**VALUE ENGINEERING STUDY**

***I-65 Widening from North of Cumberland  
Interchange to North of Munfordville  
Interchange***

**PROJECT ITEM NUMBERS: 3-12.00, 3-13.00, 3-14.00, 4-13.00, 4-14.00**

**Final Report December 13, 2010**

##### Concrete Typical Section:

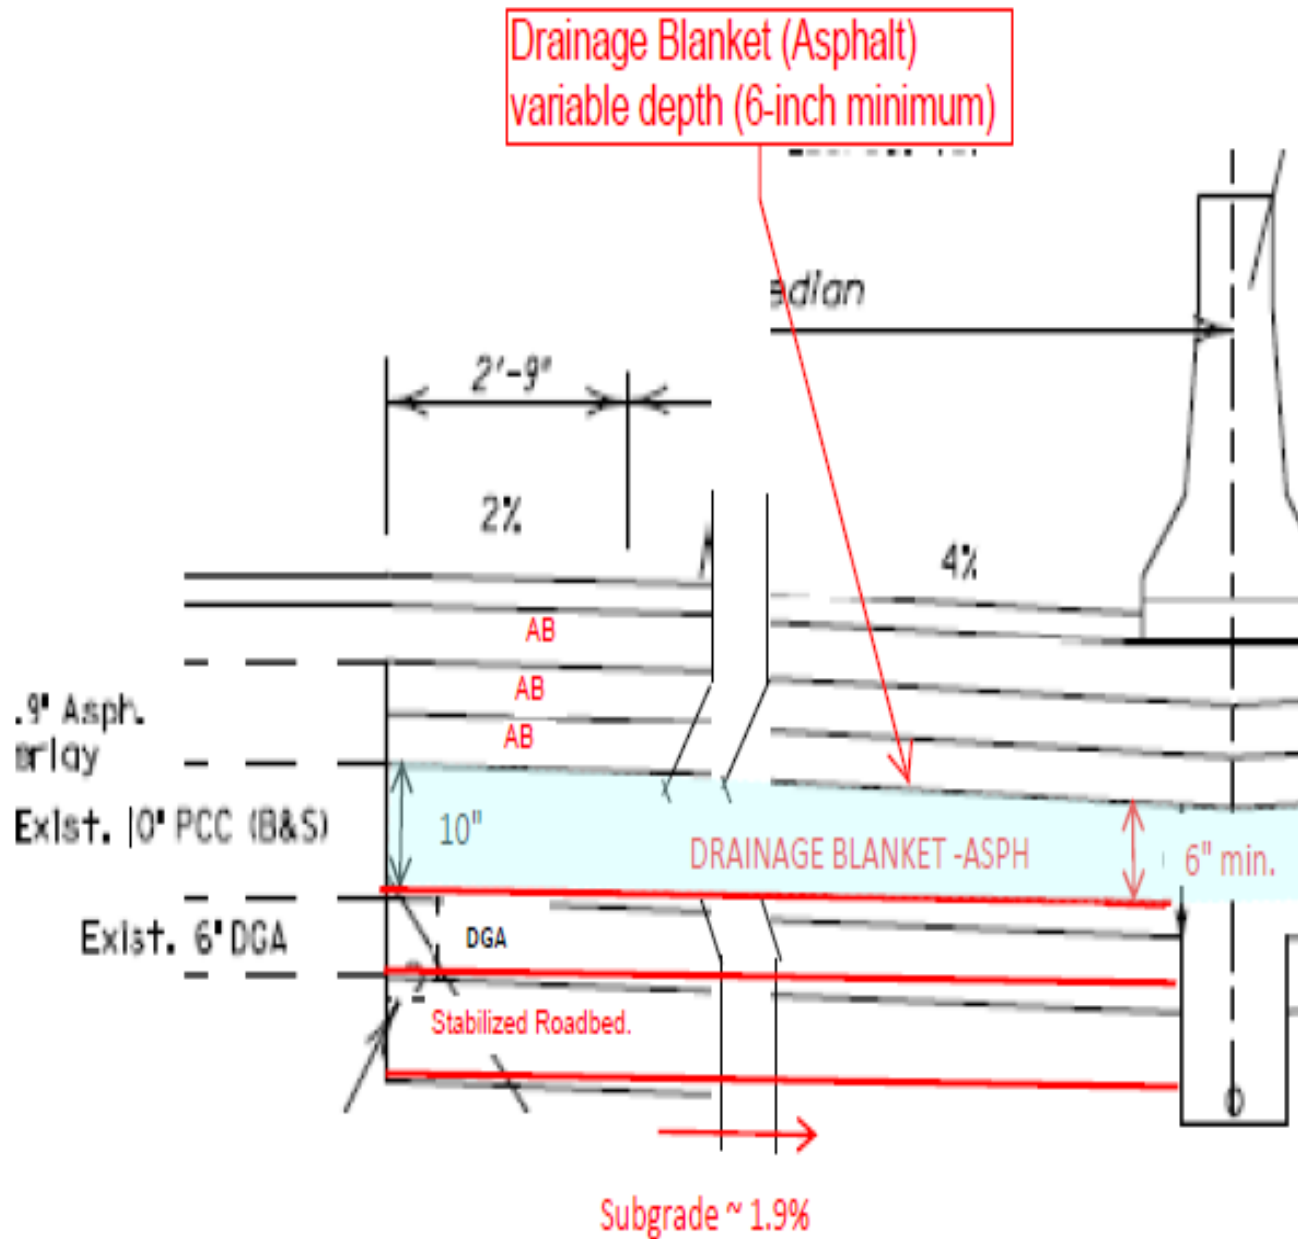
The VE Team recommends revising the typical section by tapering the thickness of cement treated drainage blanket (Type III) in the median sections down to a minimum of 7” instead of 11” at centerline. The drainage layer will remain at 12.5” at the tie-in to the existing roadway in order to maintain the drainage of the existing pavement. All other pavement layers will remain the same, with the decrease in drainage blanket layer being made by revising the sub-grade slope. This will result in an approximate 1.4” average decrease of the drainage layer thickness for the width of the median pavement.

This VE Alternative will require less drainage blanket material resulting in lower costs and reduction of construction time, while maintaining the purpose of draining pavement structure.

#### VE Alternative 1B

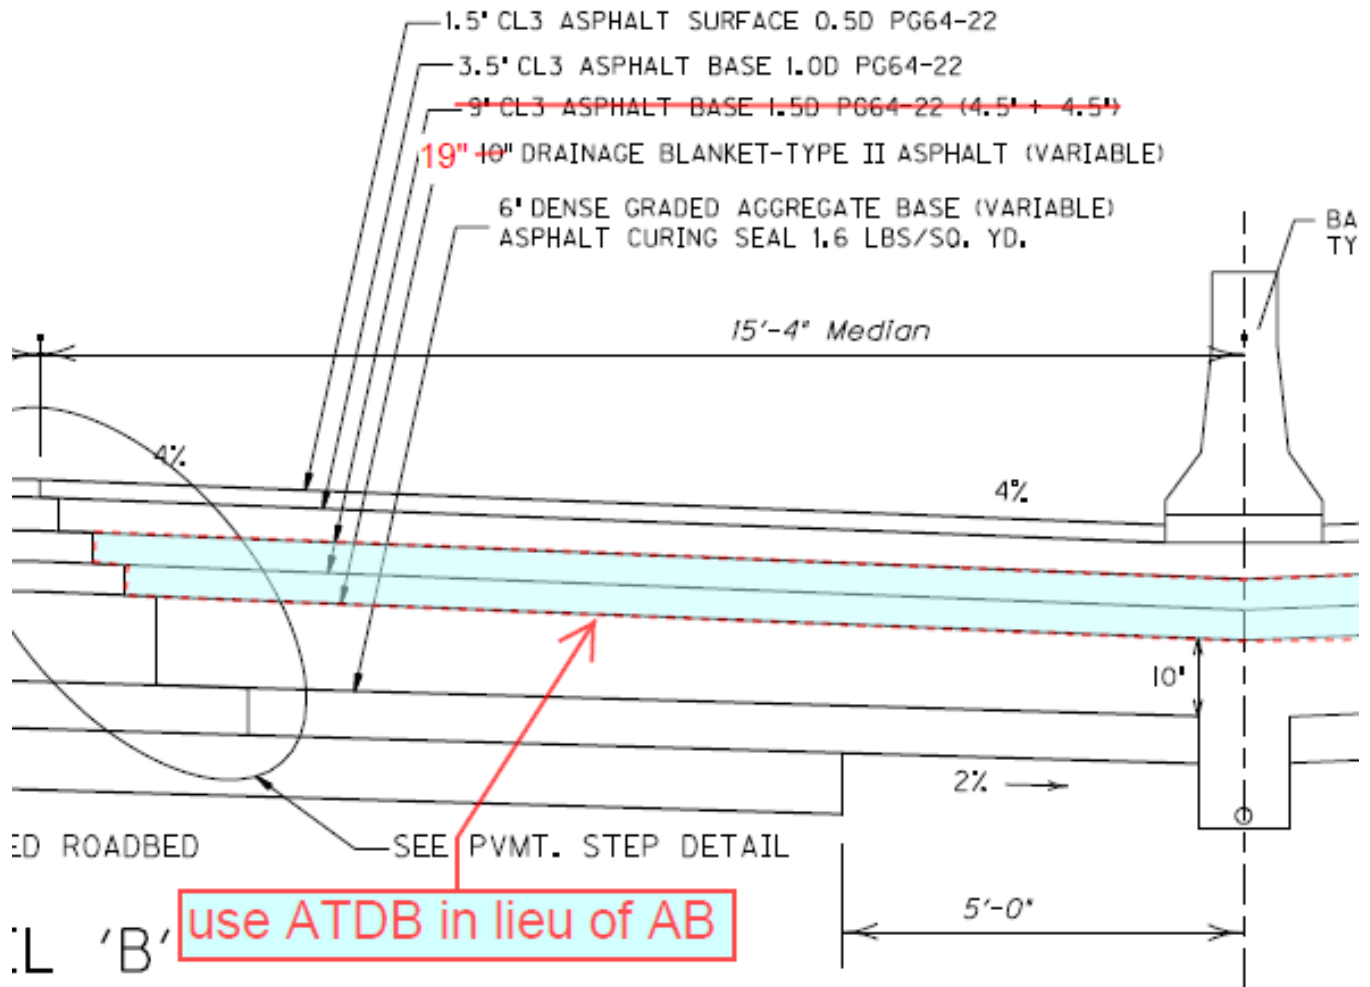
The VE Team recommends revising the pavement structure of the interior shoulders in the median sections by utilizing asphalt-treated drainage blanket (ATDB) in lieu of the proposed bottom two courses of asphalt base (AB). This would replace 9" of asphalt base with a less expensive material.

FIGURE 1

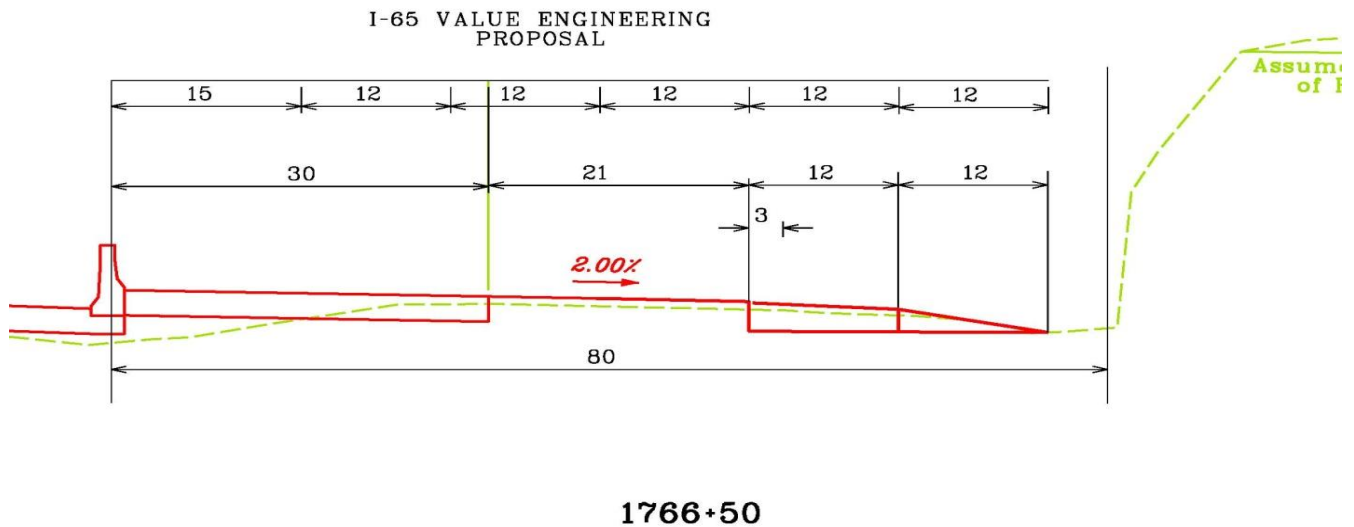
**Erosion Control and Environmental Concerns:** This area is in the Mammoth Cave Region and contains many karst features that feed into the cave system. Any work that can be avoided would lessen the impact on the area. Also, containing the work to the inside would also make it easier to contain and filter the runoff.

**Conclusion:** The VE Team proposes that the roadway be developed for the planned typical section based on the preceding information. The team VE Team proposes that the roadway be constructed according to the typical section (shown in Figure1) and no roadway excavation be done unless minimum clear zone requirements are not met. This would reduce the amount of roadway excavation by an estimated \$8,945,325. It is realized that some excavation will still need to be done as shown in Figure 2, on the outside and that some excavation is being done in the bifurcated sections that cannot be avoided. Therefore, all of the estimated savings above may not be realized, however, even being conservative the team feels that the estimated savings could be around \$ 6 million.

#### VE Alternative 3

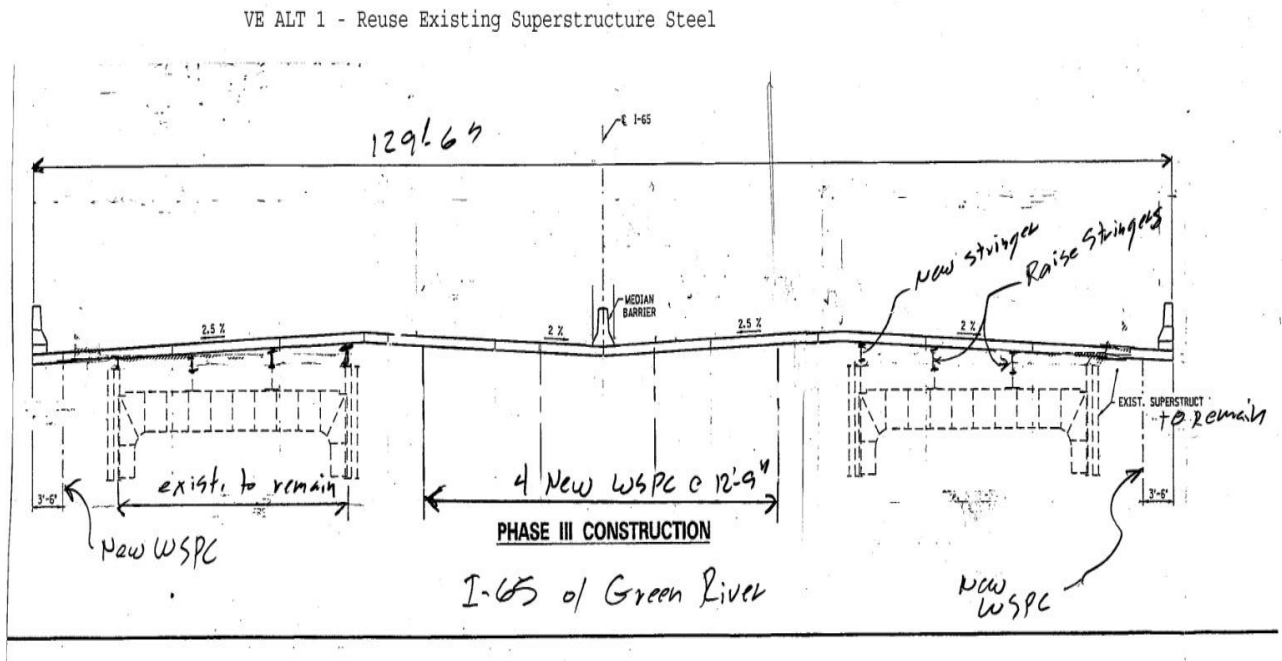
Since the existing steel girders are in relatively good condition, VE Alternative 3 is to salvage the existing steel, add new welded steel plate girders for the median area and add an exterior girder to the existing bridge while completely replacing the existing deck.

**ELEVATION VIEW of PPC 'SPLICED' I-BEAM**

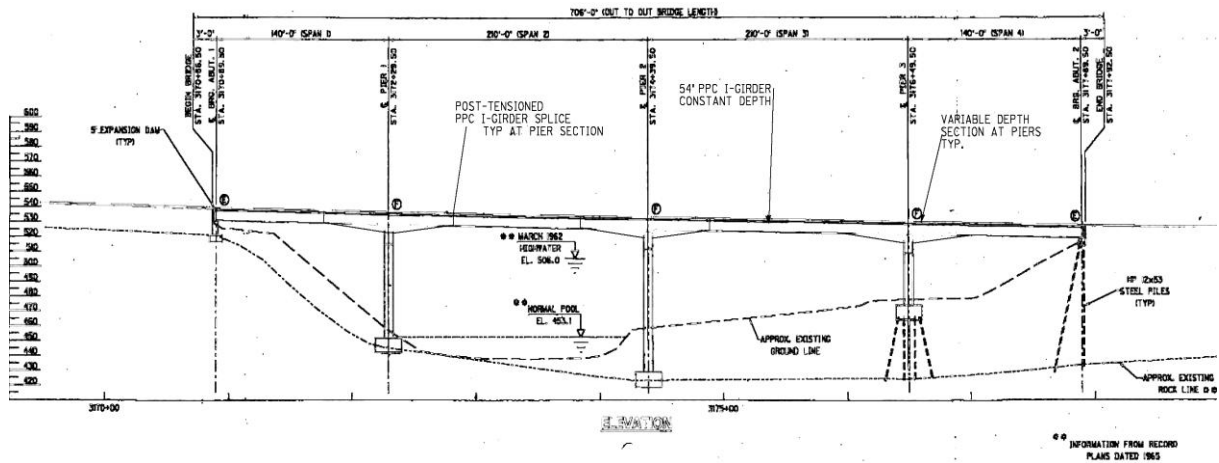
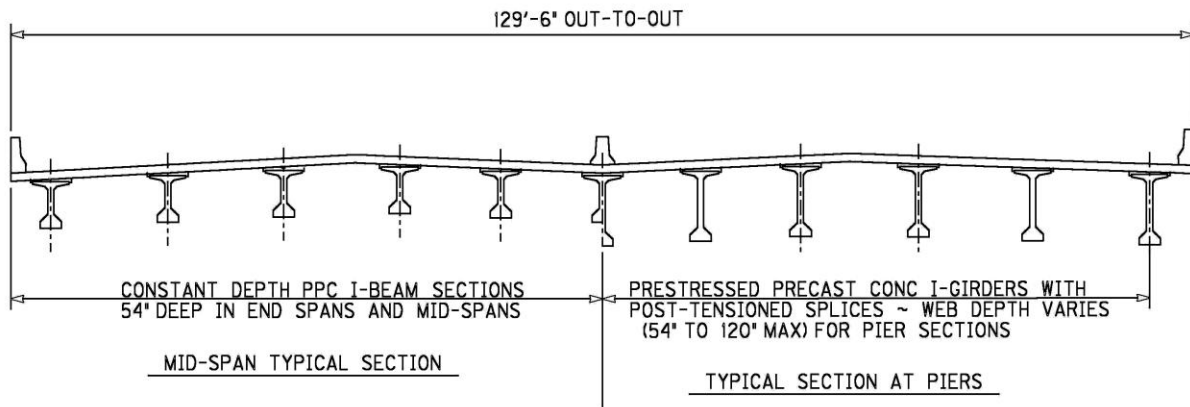
A VE Alternative 4 was considered to reduce future maintenance. This proposal would replace the entire superstructure with a new concrete superstructure using spliced Precast Prestressed Concrete (PPC) I-beams with post-tensioning at the pier sections. Although the estimated cost exceeds the original proposed bridge replacement, the cost savings in limiting future maintenance inspections, repairs, and painting should offset the increase in initial cost.

This structure would still have a lower life cycle cost.

*VE Alternative 5*

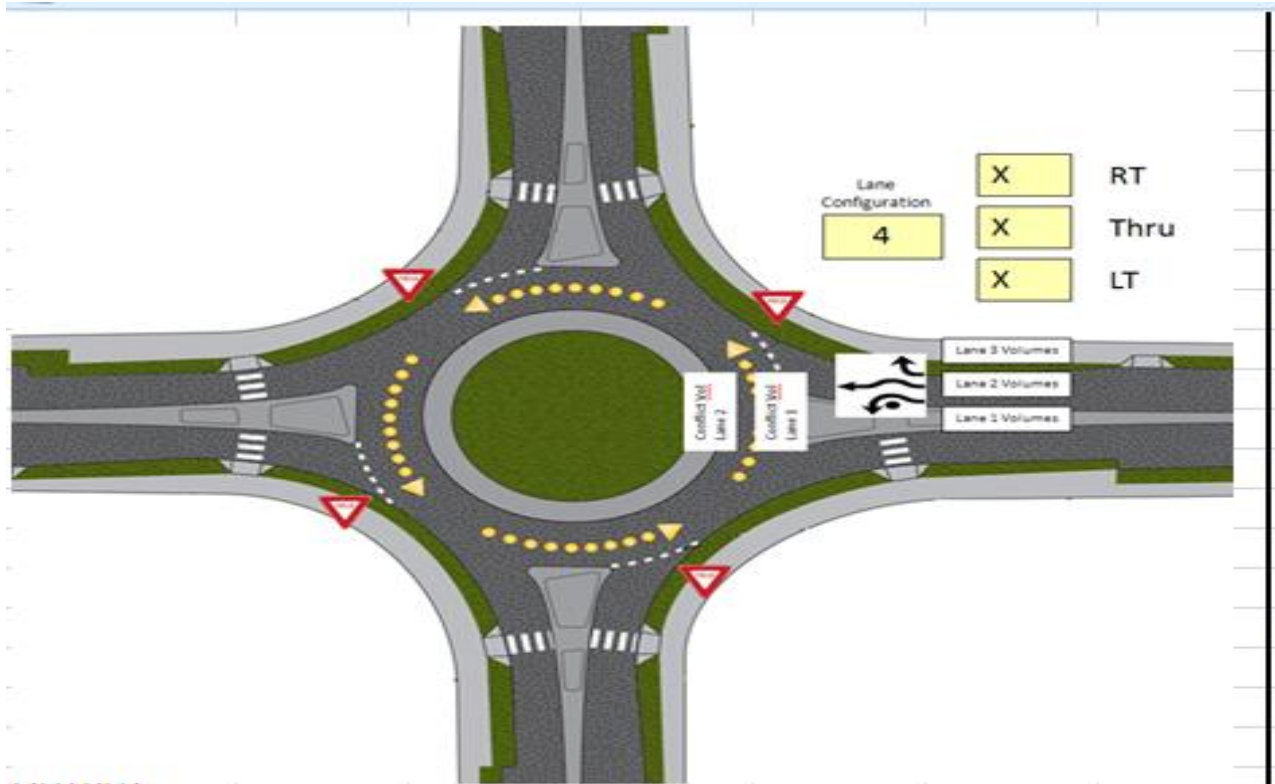
The recommendation is to add a roundabout to termini of the I 65 southbound entrance and exit ramps at US 31W. The primary purpose of adding the roundabout will be to eliminate the need for left turn lane on the western leg that would conflict with the operations of the driveways of businesses in that vicinity. This alternative provides very good traffic operations and spare capacity for future growth. Also, the use of roundabouts allows for safer operations due to low, consistent operating speeds through the intersections and a reduced number of conflict points. It appears the roundabout can be built entirely within existing right-of-way.

#### **VE ALTERNATIVE 6 I-65 BRIDGE OVER US 31W SPAN CONFIGURATION**

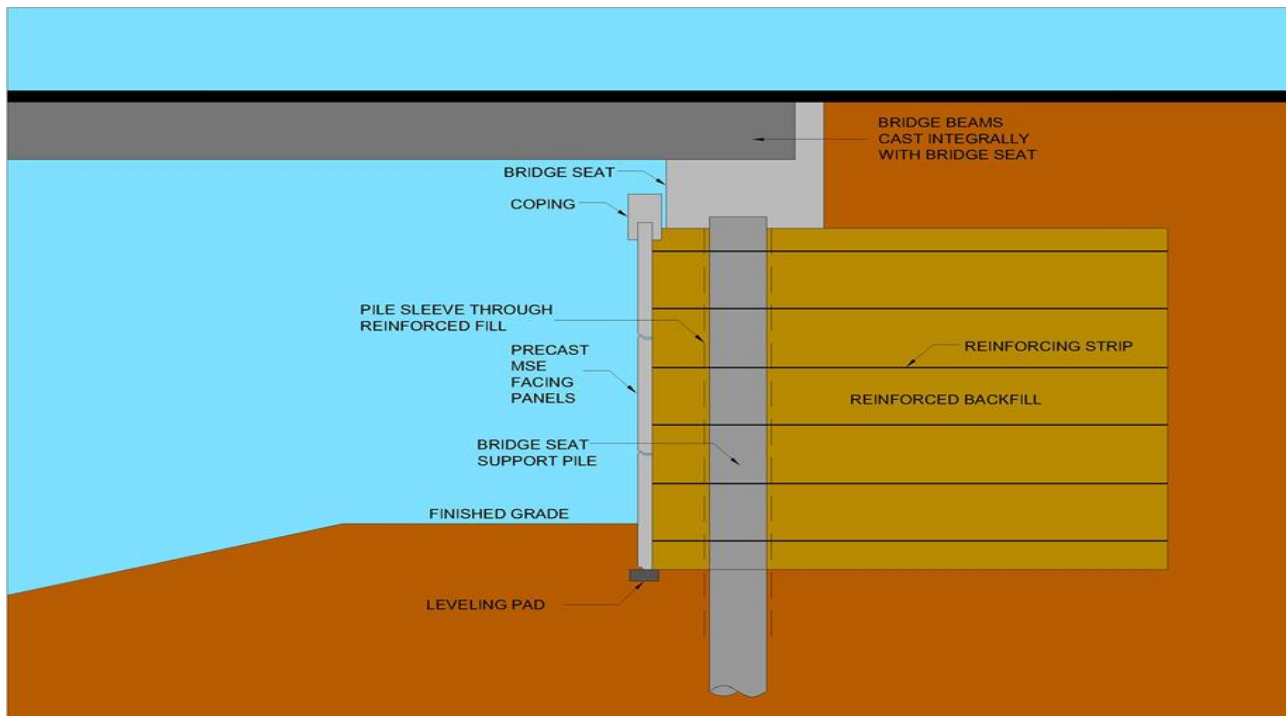
Either metal straps or Geogrid mats that extend from the wall into the earth fill a distance of 70% of the height of the wall will reinforce the earth. Using reinforced earth and panels reduces the length of the structure which saves on bridge construction and maintenance costs. With a smaller deck, there is less area that could freeze during cold weather.

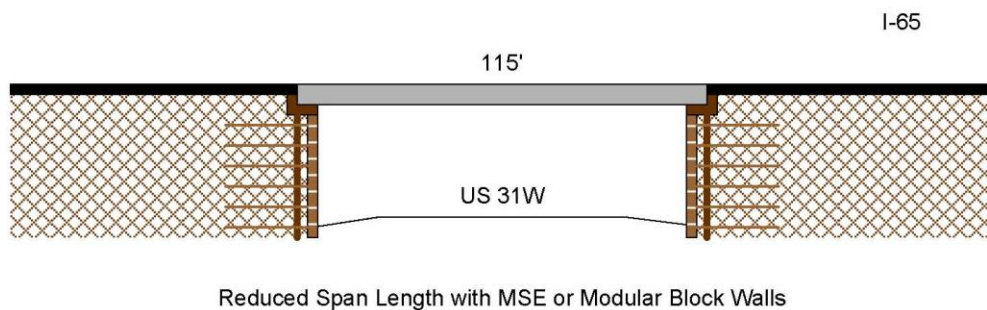
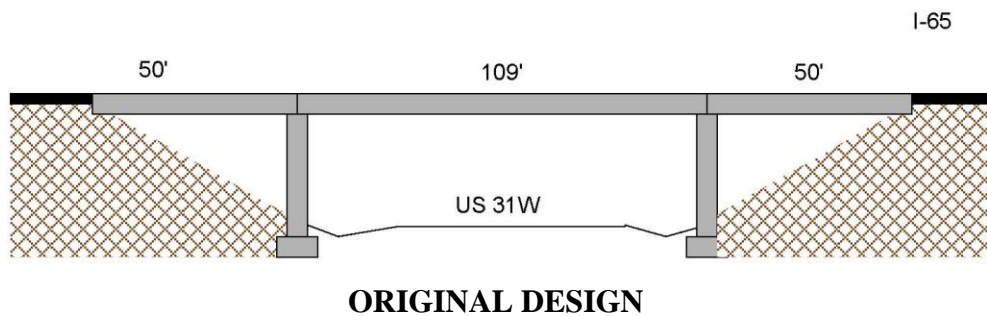
Option 1. Mechanically Stabilized Earth (MSE) Walls. The cost to replace the end spans with MSE abutments is estimated to be \$2,759,534.

Option 2. Modular Block Walls. The cost to replace the end spans with Modular Block abutments is estimated to be \$2,546,220.

Using either option, two piers on drilled shafts and approx. 85' of span for the 129.5' wide superstructure ( $85 \times 129.5 = 11,0008$  SF) are eliminated. The single span is supported by integral end bents which are supported by sleeved piles through the MSE or Modular Block Wall backfill which retains the roadway embankment.

#### **Option 2: Roundabout Intersections, Narrow Bridge, Shortened Bridge**

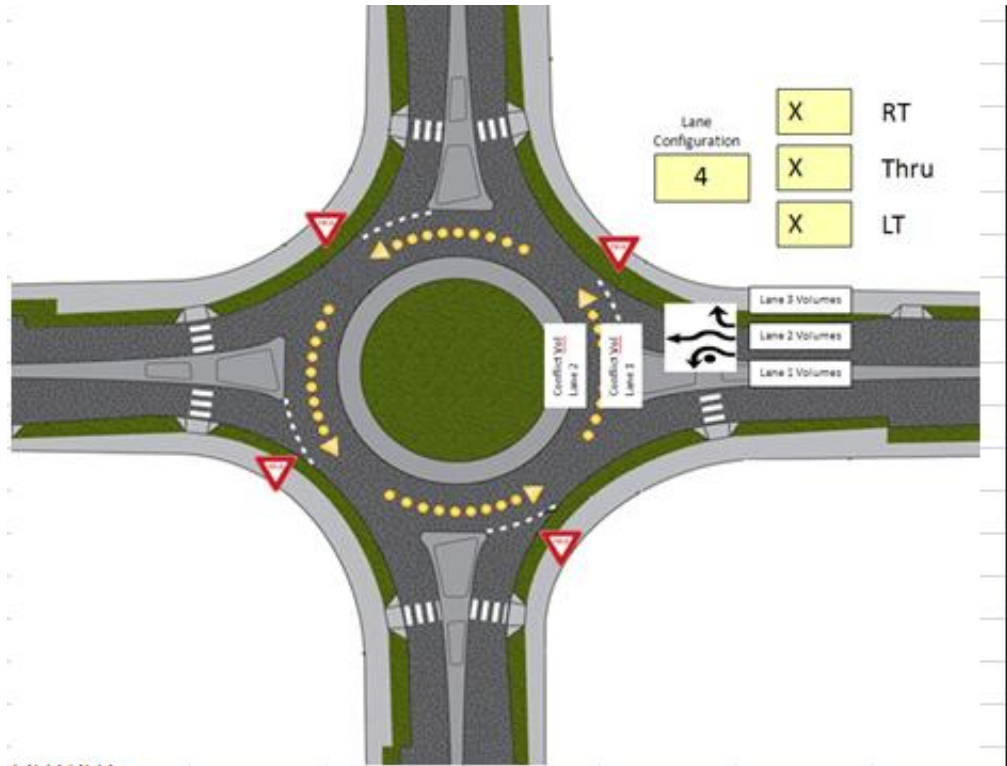
This keeps the same interchange and lane configurations as in Option 1, but provides for a two-span bridge, rather than four. This reduces the total bridge length by 98' (298' versus 200'). This is achieved using either a Mechanically Stabilized Earth (MSE) or Modular Block Vertical Wall abutment.

#### **VE ALTERNATIVE 10, I-65 BRIDGE OVER KY 218 SPAN CONFIGURATION**

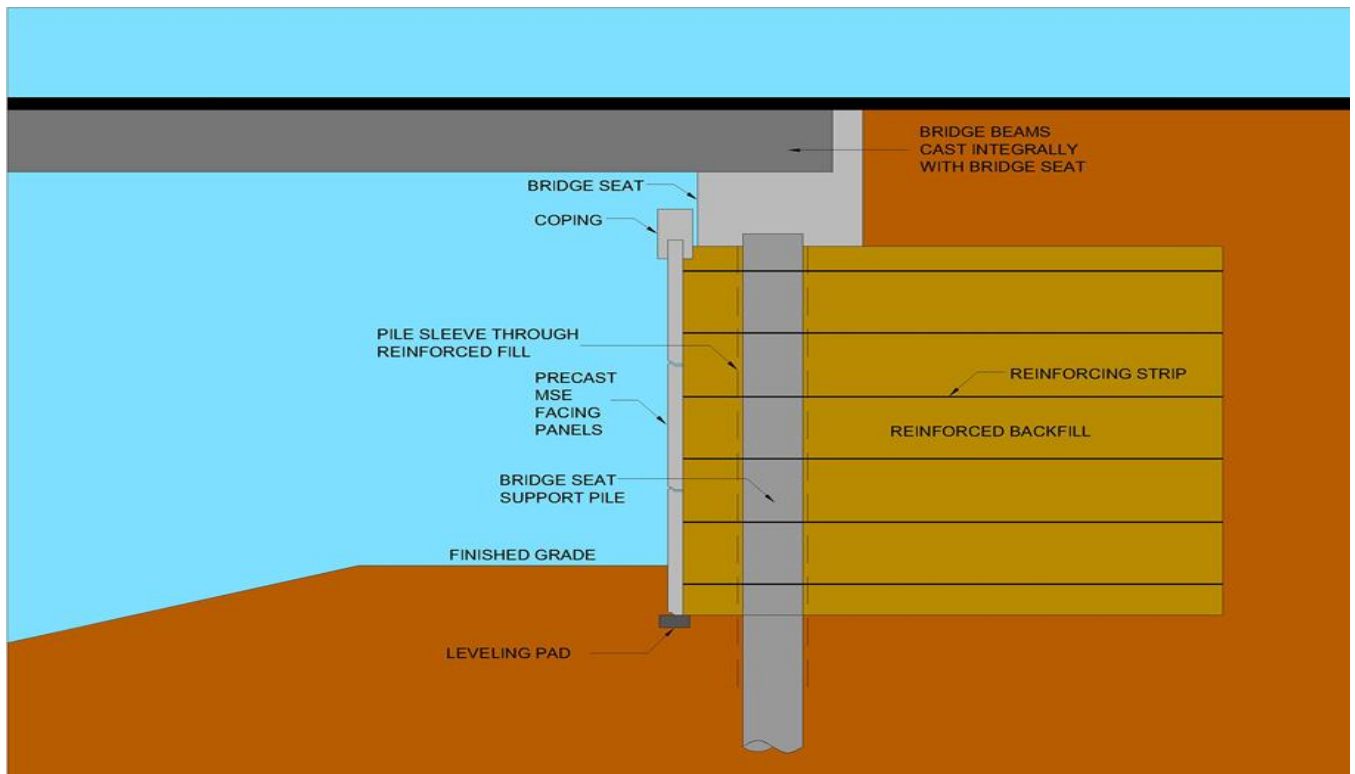
Either metal straps or Geogrid mats that extend from the wall into the earth fill a distance of 70% of the height of the wall will reinforce the earth. Using reinforced earth and panels reduces the length of the structure which saves on bridge construction and maintenance costs. With a smaller deck, there is less area that could freeze during cold weather.
